From: David Lukcic [dmlukcic@tecoenergy.com]
Sent: Thursday, April 06, 2006 8:39 AM
To: www.tom.cascio@deo.state.fl.us
Subject: CBO Permit Additional Information

**Re: Tampa Electric Company
Big Bend Station
Air Construction Permit Application for
Fly Ash Carbon Burn-Out (CBO™) Project**

Thank you for your letter received on September 28, 2005, written in response to our request for additional information concerning your air construction permit application received on August 8, 2005, for the subject project. However, we must deem your application still *incomplete*, because we need further information relative to the following items:

CEM SYSTEM BLOCK DIAGRAM

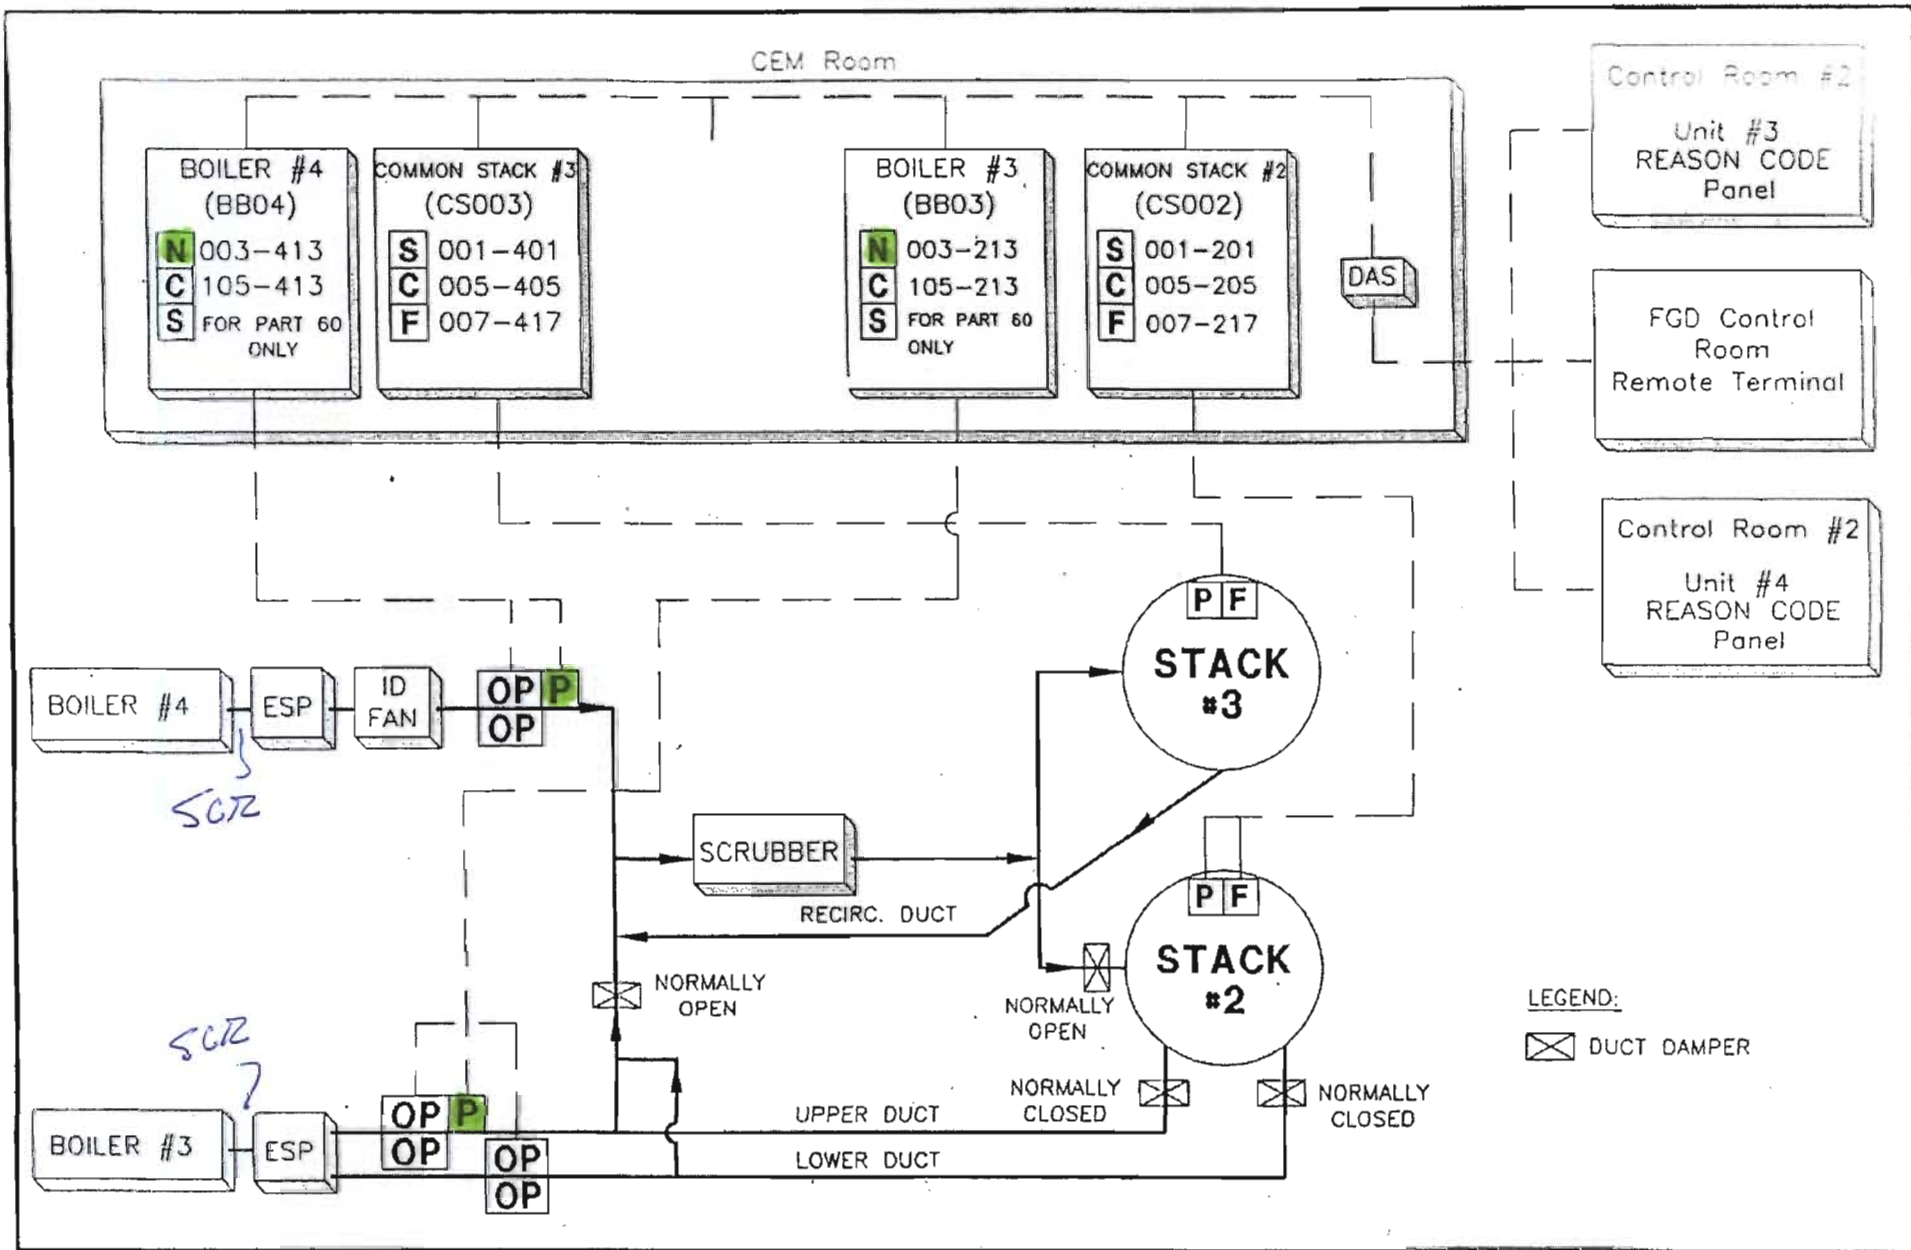
I wanted to clarify where we were currently proposing to monitor . This could change once discussions are finalized with the EPA. Currently we would keep the existing CEMS monitor where it is to monitor the boiler emissions. We would then introduce the CBO stream after the ESP's and one of two options. 1) An annual stack test for compliance of the CBO stream. or 2) place an additional CEMS after the streams combined and monitor the combines for a NOx limit of .15.

Figure 1. Big Bend Unit 3 & 4 Nitrogen Oxides (NO_x) Emissions

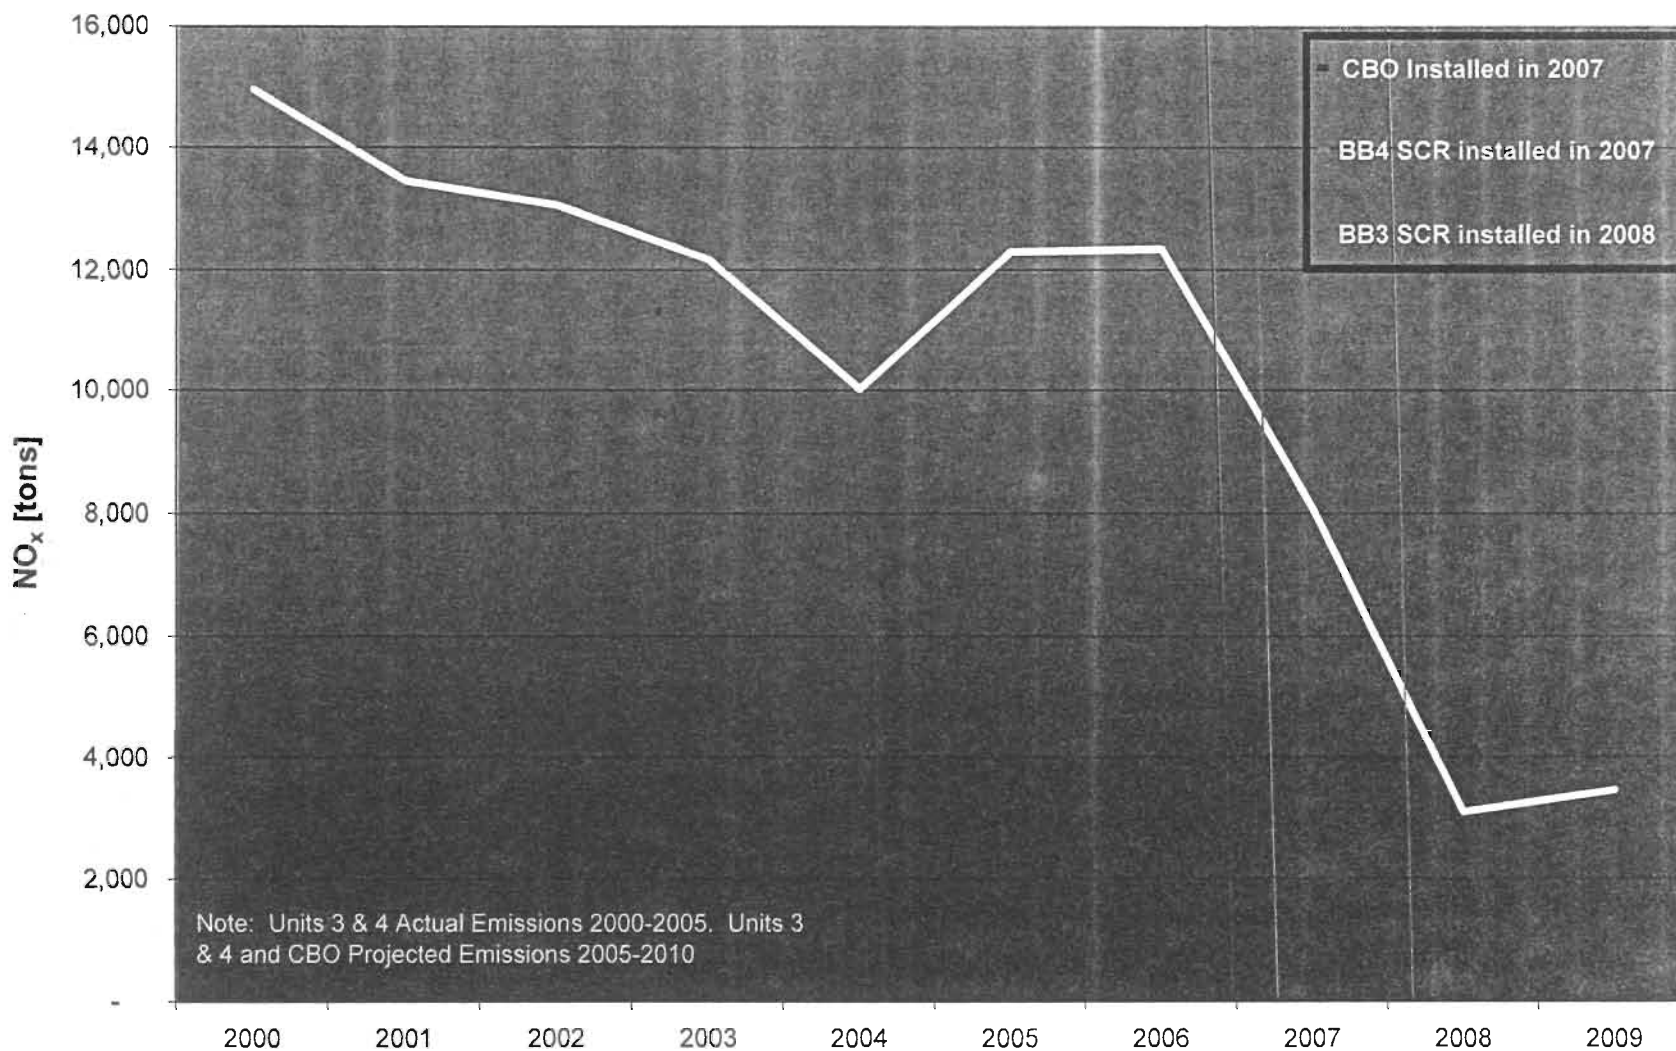
the project is thus not a major modification due to NO_x emissions. Actual CO emissions from Big Bend Units 3 and 4 after installation of the CBO™ are expected to be only slightly more than pre-change actual CO emissions from these units. This CO emissions increase is less than the CO significance level of 100 tons per year; thus, the project is also not a major modification for CO emissions. Enclosed in Attachment A are the corresponding graphs for NO_x and CO emissions data.
